18TG Housing Changes

Changes – 16TG vs 18TG

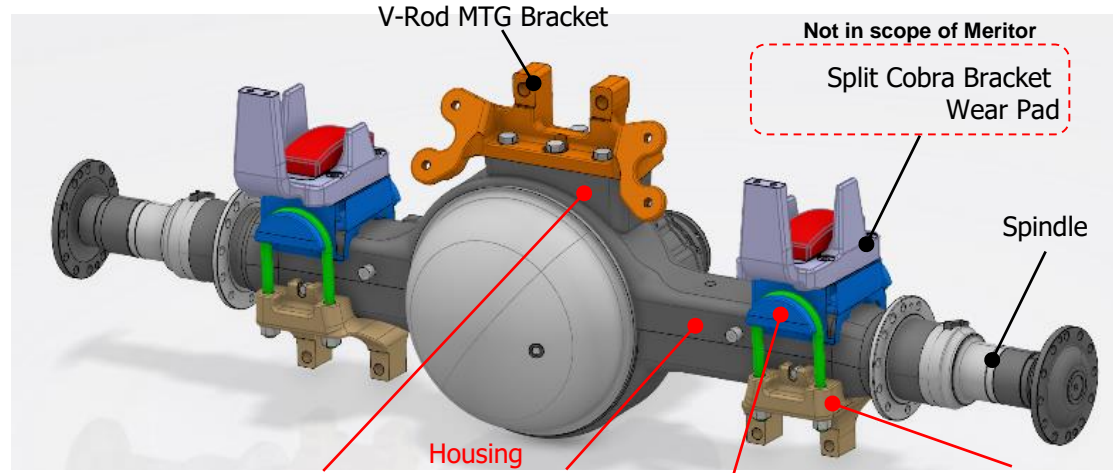
Changes in Housing Box Section :

Housing	16TG	18TG
Box Section	154x140x14	158x145x16

- Changes in Suspension Mounting Brackets due to Box Section Change,

- Top Dome Bracket
- Middle Block
- Bottom Bracket

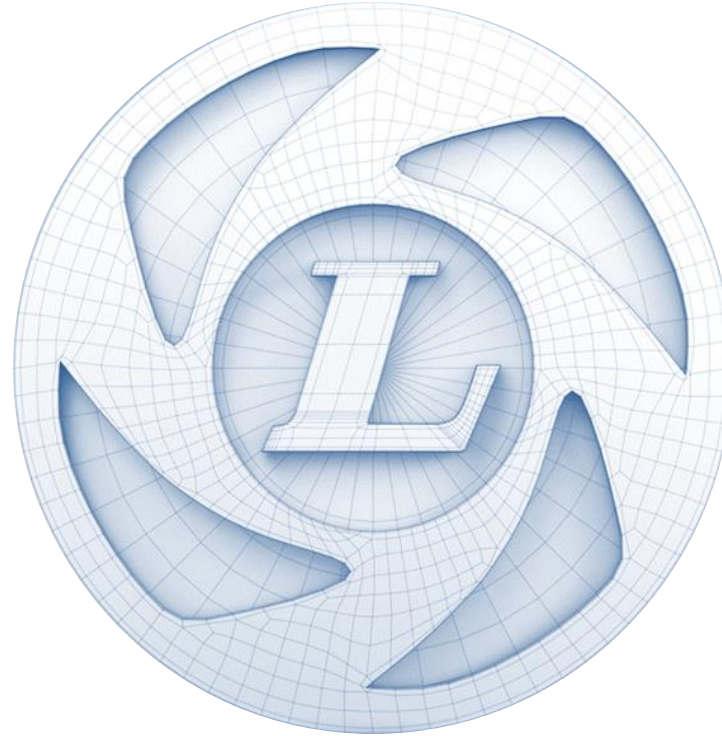
- No Changes in V-Rod MTG Bracket.
- Changes in Spindle internally.
- No Changes in Wheel End parts

Top Dome bracket (weld)

Spring Seat / Middle Block

Bottom Bracket

All Changes are due to Housing Box Section Changes
